October 28, 2020

Re: American Exchange Development Proposal

PUBLIC AMENITIES – AC HOTEL & ENO VINO LAND USE BACKGROUND

Jose & Sara Granados, Owners of Eno Vino Downtown John Smithe, Owner of Eno Vino Downtown Craig Spaulding, Bartender at Eno Vino Downtown Bridget Maniaci, Principal at UX Community Consulting, LLC Robert Procter, Partner at Axley Brynelson, LLP APPENDIX A Examples of Existing ULI Rooftop Mechanicals

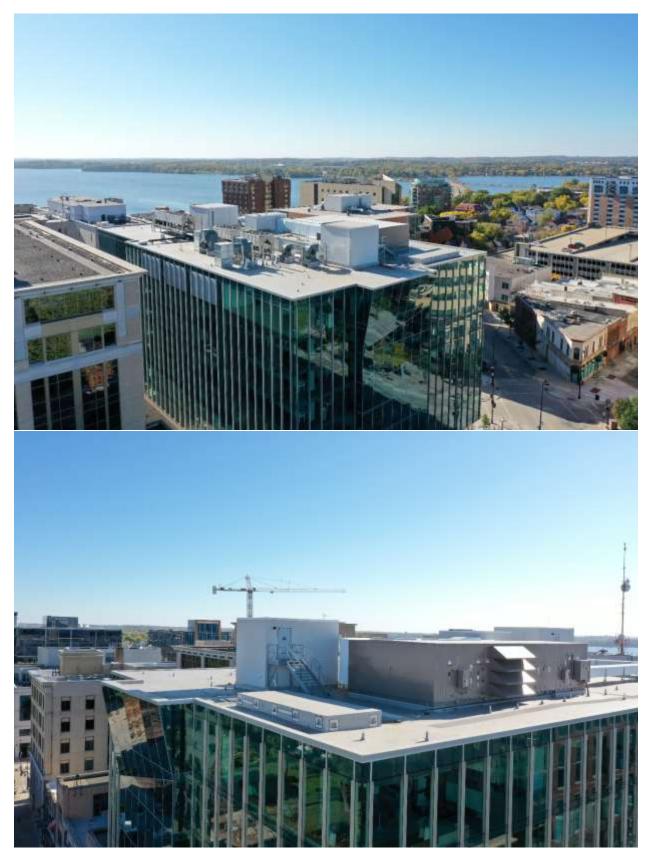
Additionally, please see Appendix A for examples of recently constructed rooftop mechanical elements by Urban Land Interest on the Capitol Square that demonstrate examples of unattractive and obstructive mechanical towers that would be detrimental to those visiting and using the Eno Vino space if such mechanical elements are built as currently proposed within the AED Project.

Based upon the analysis conducted by NCG, we believe that the mechanical tower can be shifted to a central, mid-block position, allowing for minimal impact to the public amenity spaces of Eno Vino's restaurant and a marginal impact to the AED Project's functionality, use, and overall building massing.
